From: Jackie Archer
Sent: 25/05/2022 1:45:42 AM
To: Council Northernbeaches Mailbox
Subject: Modification of Development DA2020/1453
Attachments: Revised submission - DA2020-1453.pdf;

Submission for DA2020/1453 - revised – 1 Alexander St and 4 Collaroy St, Collaroy NSW 2097

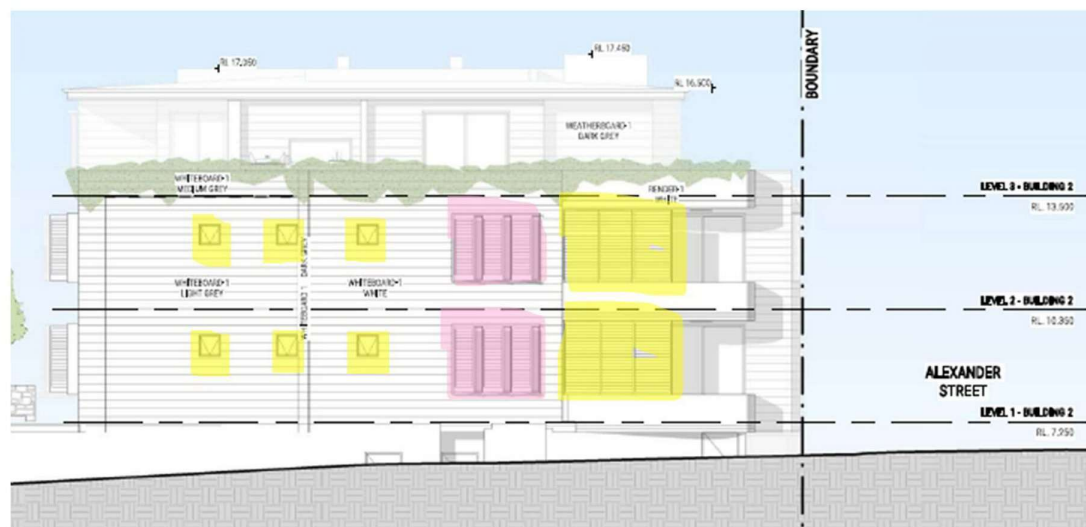
We note that the revised plans show that balconies on levels 1 and 2 now have screens in place, however the composition and length of the screens are not specified. Our preference is to have these screens fixed and not removable. As this is a major concern for us, it is now paramount that we be advised of the type and composition of the screening that has been proposed by HCAP.

Regarding our proposal to have frosted glass on all bathroom windows, would you confirm this has been implemented as there are no screens shown below; and also kindly provide confirmation of the screening in pink (for the bedrooms).
